DEVELOPMENT APPLICATION ASSESSMENT REPORT

Application Number:	DA2023/0577
----------------------------	-------------

Responsible Officer:	Alex Keller
Land to be developed (Address):	Lot 1 DP 332220, 1168 Barrenjoey Road PALM BEACH NSW 2108
Proposed Development:	Demolition works and construction of a dwelling house, garage, swimming pool and spa
Zoning:	C4 Environmental Living
Development Permissible:	Yes
Existing Use Rights:	No
Consent Authority:	Northern Beaches Council
Land and Environment Court Action:	No
Owner:	Martin Nicholas Cork Lisa Joy Cork
Applicant:	Martin Nicholas Cork Lisa Joy Cork

Image: Height line using 8.5 and 10m height line along natural ground level. (Some natural sections of the slope are near vertical rock outcrops)

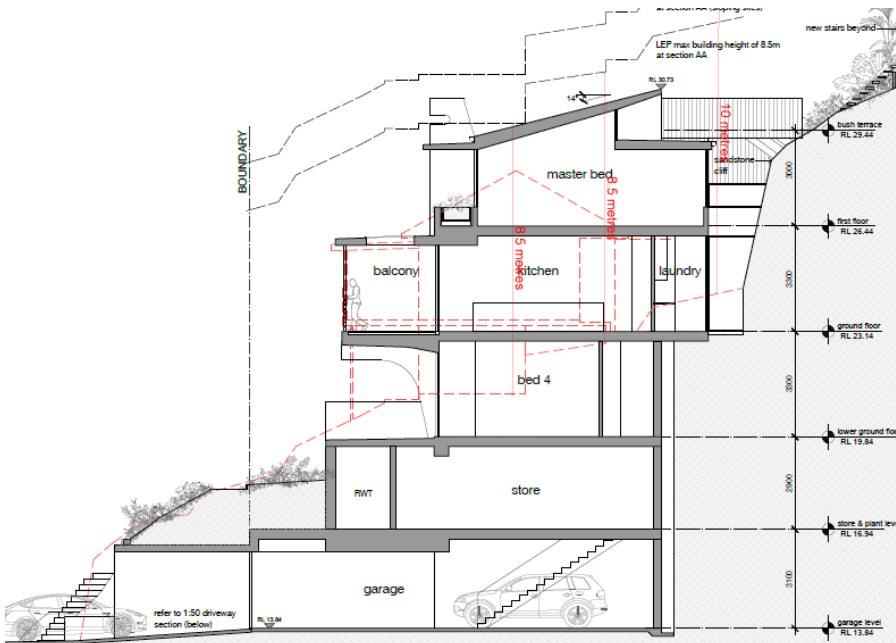
Note: The currently has some benching and excavated areas for the 'existing ground level'. Height is measured pursuant to the approach taken in *Merman Investments Pty Ltd v Woollahra Municipal Council [2021] NSWLEC 1582* the existing excavated ground level measured as per the architectural sections.

The diagram also demonstrates the building height as measured by the alternate method used in *Bettar v Council of City of Sydney [2014] NSWLEC 1070* in which the building is 7.4m high based on extrapolated natural ground line.

- The slope of the land across the building footprint exceeds 16.7 degrees and excavation is utilized to provide vertical access within the house via a lift and stairs. At the rear the top level include a walkway to small level area. Overall the new dwelling is positioned over the original building platform and steps back and upward to follow the natural slope up to a natural cliff point and to reach a small flat area above. The rear boundary is approximately 15m higher than the upper roof level of the house.

Image: Front setback non-compliance for the ground floor. Note existing walls retained (black).

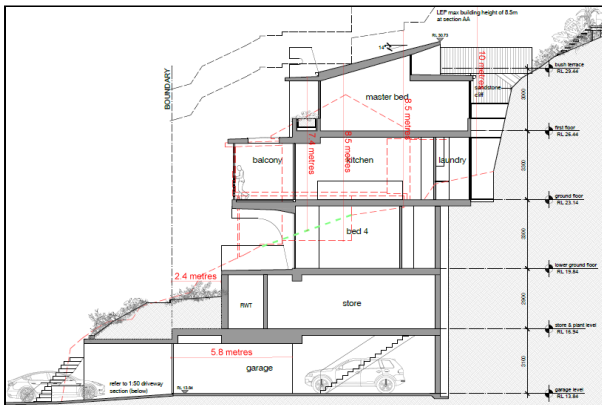
Clause D12.5 requires development to provide a minimum front setback of 6.5m. The proposed ground floor walled elements of the rainwater tank structure and pool are setback 1.0m to 2.5m, influenced by the intermediate level, used to infill the gap to the higher new ground floor that is similar to the existing ground floor thus allowing the living area higher up to take advantage of views to Pittwater. Additionally, the rear of the house is 'hemmed-in' by a cliff-line at the back that is being kept in situ.
